**RE: *Meliadine Mine Updated Management Plans 2AM-MEL1631***

Agnico Eagle Mines Limited (Agnico Eagle) thanks the Nunavut Water Board (NWB) for the opportunity to address comments received for Agnico Eagle's Meliadine Gold Mine updated Management Plans submitted on February 7<sup>th</sup>, 2025 as per Part B, Item 14 of the amended Water Licence 2AM-MEL1631.

**ECCC-1: SLUDGE MANAGEMENT IN WATER MANAGEMENT PLAN**

***TIR02 observed and predicted volumes from the Operational WBWQM.***

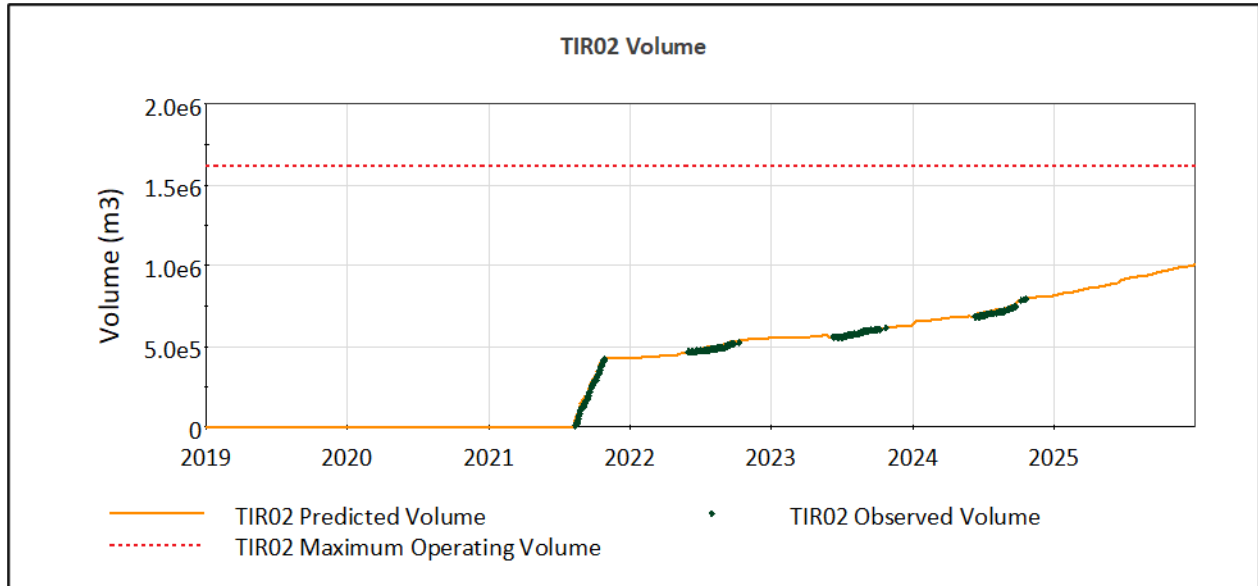
The Proponent provided information on the assumed solids contents of sludge from the future Saline Effluent Treatment Plan (SETP). They also stated there are two versions of the Water Balance and Water Quality Model (WBWQM): operational and water licence amendment (WLA). The response states that though the WLA model does not consider sludge inputs, the operational model does. Though it is expected that quantities and flows in an operational WBWQM would be updated more frequently to incorporate dynamic site conditions, all sources and sinks should be included in the WBWQM and shared through the Nunavut Water Board for reviewers to understand how water is being managed. If the operational model already incorporates sludge volumes, this information should be able to be provided to reviewers.

The Proponent will provide further details on the sludge produced by the ammonia treatment train of the future SETP once they are known, but no timeline has been specified. Since saline water production is ongoing, saline pond capacity is limited and treatment is required prior to discharge, the timing of SETP construction and commissioning has an incidence on saline water management on site that should be reflected in the WBWQM.

ECCC recommends the Proponent provide a WBWQM that accounts for sludge deposition in the saline water storage ponds. Additionally, they should provide a timeline for discharge of saline water to Itivia Harbour through the SETP and waterline, to be incorporated in the WBWQM.

Agnico Eagle confirms that sludge discharged quantity and impact on water quality are included in the Operational WBWQM results presented in the 2024 Annual report.

The waterline operation presented in the WLA WBWQM assumes a commissioning in 2025 with a seasonal discharge window from June 20 to September 29. However, construction of the waterline will continue in 2025 and thus this assumption will be revised in the next update and submission of the model.

However, assuming these delays, the forecast of the saline water storage in Tiriganiaq Open Pit 2 (TIRI02) of the WLA WBWQM is anticipated to closely reflect the projections of the Operational WBWQM in 2025. Saline water storage in TIRI02 is forecasted to reach 1,005,000 m<sup>3</sup> at the end of 2025, leaving 611,500 m<sup>3</sup> of storage capacity (see figure below).

Agnico Eagle commits to update the current Operational and WLA WBWQMs to combine them into a single WBWQM. This WBWQM update will be conducted and provided to regulators within the 2025 Annual Report. The model update will present the expected discharge of saline water to Itivia Harbour through the SETP and waterline, and capture potential impacts of sludge quantity and quality on receiving storage containment.
